Summary of Additional Information – Part 2

SUBJECT: File No. 6013.10 - RM of Springfield Water Treatment Plant Upgrades – Information for Public Registry

SUBJECT: RM OF SPRINGFIELD, WATER TREATMENT FACILITY UPGRADE, FILE 6219.00

Multiple Station Time-Series Comparison

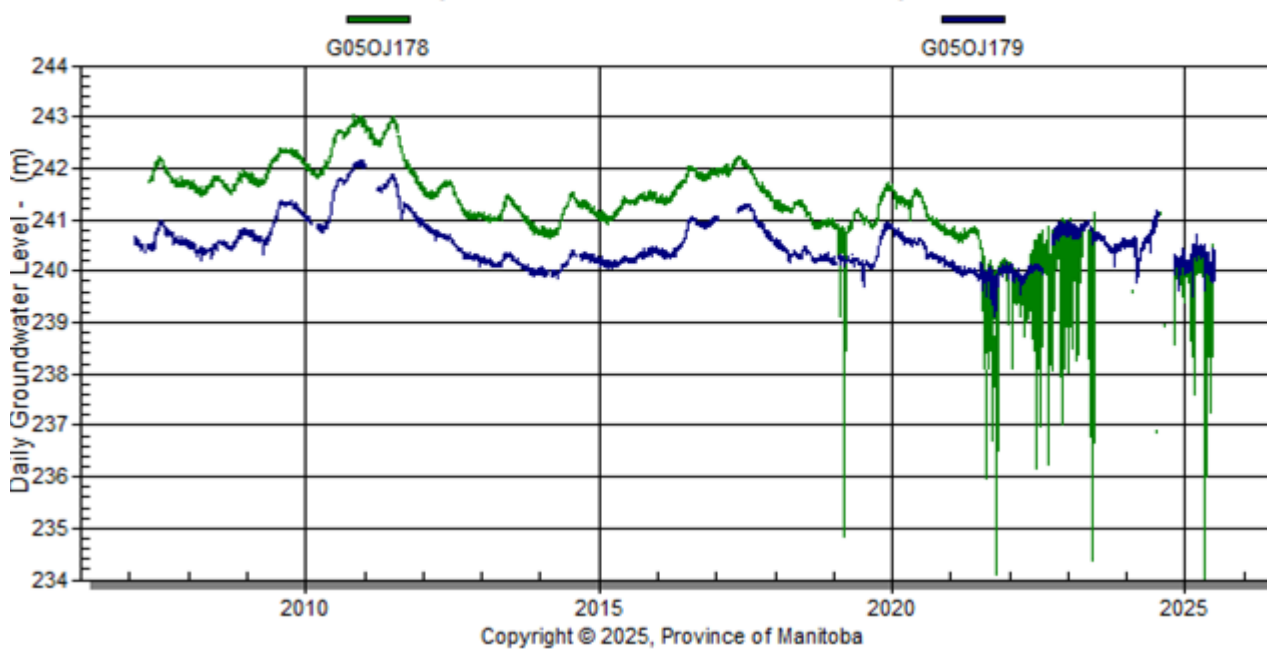
6. [page 56 – 13.2] Hydrograph data from provincial wells completed in both the sandstone and carbonate aquifers (OJ178 and OJ179) show that the groundwater level response in the carbonate aquifer at OJ179 is significantly greater than 5% of the drawdown in the sandstone, especially during periods of municipal pumping. The attached hydrograph of both demonstrates that cumulative impacts in the carbonate aquifer may be much greater than concluded in the report, particularly in the context of future, long-term operations. In addition, the time-series comparison of groundwater levels at stations G05OJ178 and G05OJ179 clearly shows a persistent head difference (gap) between the two aquifers prior to 2021, reflecting the confining effect of the intervening shale layer. However, since mid-2021, this head gap has largely disappeared, with groundwater levels in both aquifers converging and fluctuating together. This loss of head separation strongly suggests that the confining effect has been compromised, most likely due to increased municipal pumping. As a result, the hydraulic connection between the sandstone and carbonate aquifers has been enhanced, allowing pumping impacts to rapidly transmit between both units
